Planning Commission Staff Report

May 19, 2016

Case No:	16zone1010
Request:	Change in zoning from R-4 to PEC on approximately 4.46 acres
Project Name:	Air Hydro Power Expansion
Location:	2550 Blankenbaker Pky
Owner:	MOB Investments LLC
Applicant:	MOB Investments LLC
Representative:	Dinsmore & Shohl; Land Design & Development
Jurisdiction:	Louisville Metro/City of Jeffersontown
Council District:	20 – Stuart Benson
Case Manager:	Julia Williams, RLA, AICP, Planner II

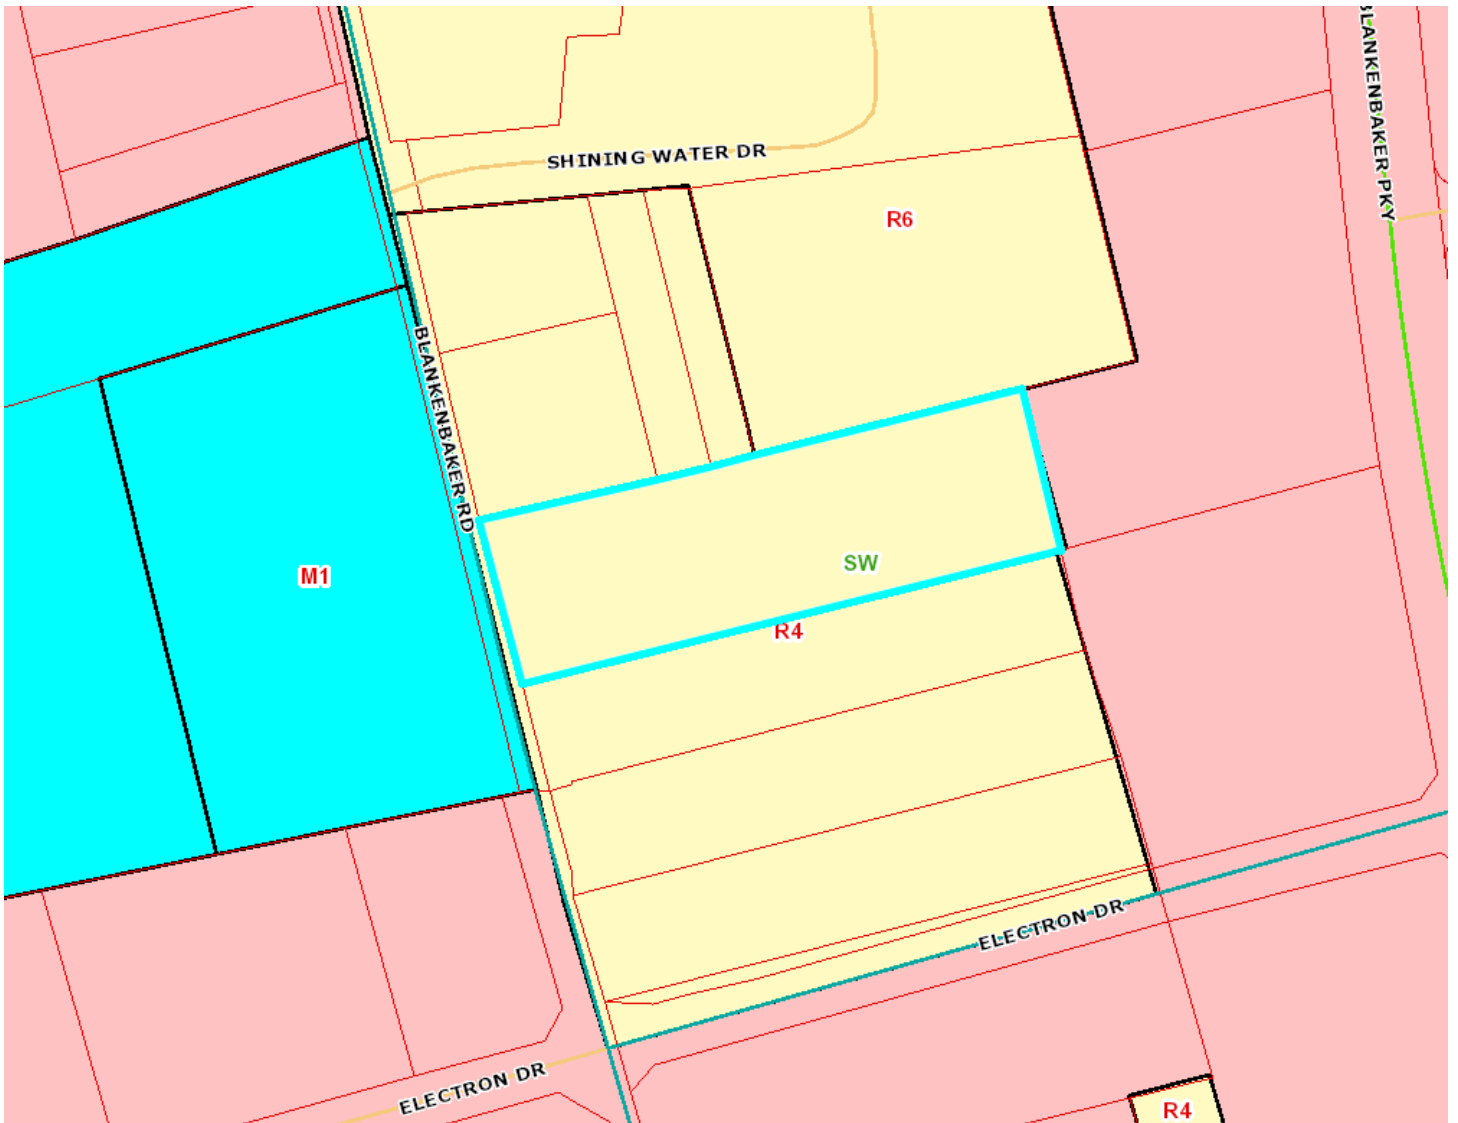
**STANDARD OF REVIEW AND STAFF ANALYSIS FOR WAIVER of section 5.5.4.B.1
to reduce the required LBA from 50' to 15' and eliminate the 6' berm along the south property
line.**

STAFF: The waiver will not adversely affect adjacent property owners since a buffer, trees and screening will be provided.

STAFF: Guideline 3, policy 9 of Cornerstone 2020 calls for the protection of the character of residential areas, roadway corridors and public spaces from visual intrusions and mitigate when appropriate. Guideline 3, policies 21 and 22 calls for appropriate transitions between uses that are substantially different in scale and intensity or density, and to mitigate the impact caused when incompatible developments occur adjacent to one another through the use of landscaped buffer yards, vegetative berms and setback requirements to address issues such as outdoor lighting, lights from automobiles, illuminated signs, loud noise, odors, smoke, automobile exhaust or other noxious smells, dust and dirt, litter, junk, outdoor storage, and visual nuisances. Guideline 3, policy 24 states that parking, loading and delivery areas located adjacent to residential areas should be designed to minimize the impacts from noise, lights and other potential impacts, and that parking and circulation areas adjacent to streets should be screened or buffered. Guideline 13, policy 4 calls for ensuring appropriate landscape design standards for different land uses within urbanized, suburban, and rural areas. Guideline 13, Policy 6 calls for screening and buffering to mitigate adjacent incompatible uses. The intent of landscape buffer areas is to create suitable transitions where varying forms of development adjoin, to minimize the negative impacts resulting from adjoining incompatible land uses, to decrease storm water runoff volumes and velocities associated with impervious surfaces, and to filter air borne and water borne pollutants. A buffer, trees and screening will still be provided.

STAFF: The extent of the waiver of the regulation is the minimum necessary to afford relief to the applicant since a buffer, trees and screening will be provided.

STAFF: The strict application of the provisions of the regulation would deprive the applicant of the reasonable use of the land or would create an unnecessary hardship on the applicant since a buffer, trees and screening will be provided.
